### 145.2.5.6 Functions

Figure 145-13—Top level PSE state diagram (continued)

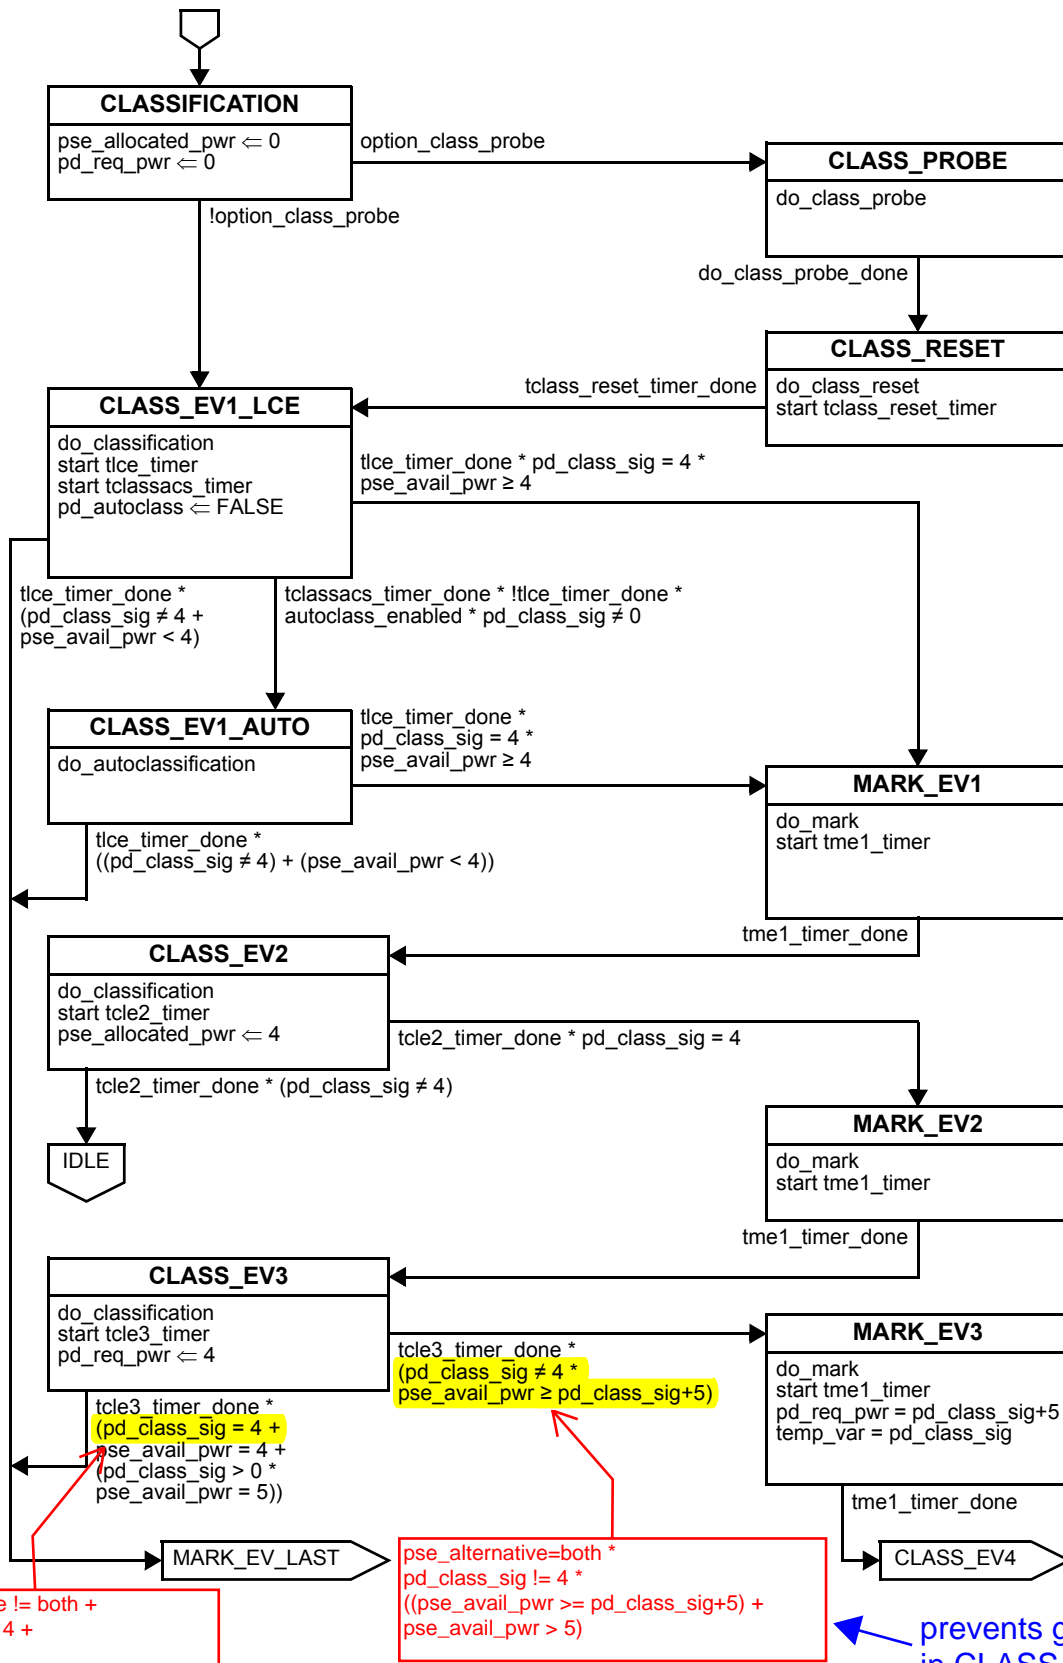
More than 3 class events only possible if **pse\_alternative=both**, this further implies that 4P powering is possible.

prevents getting stuck in CLASS\_EV3 when need to power demote in EV4.
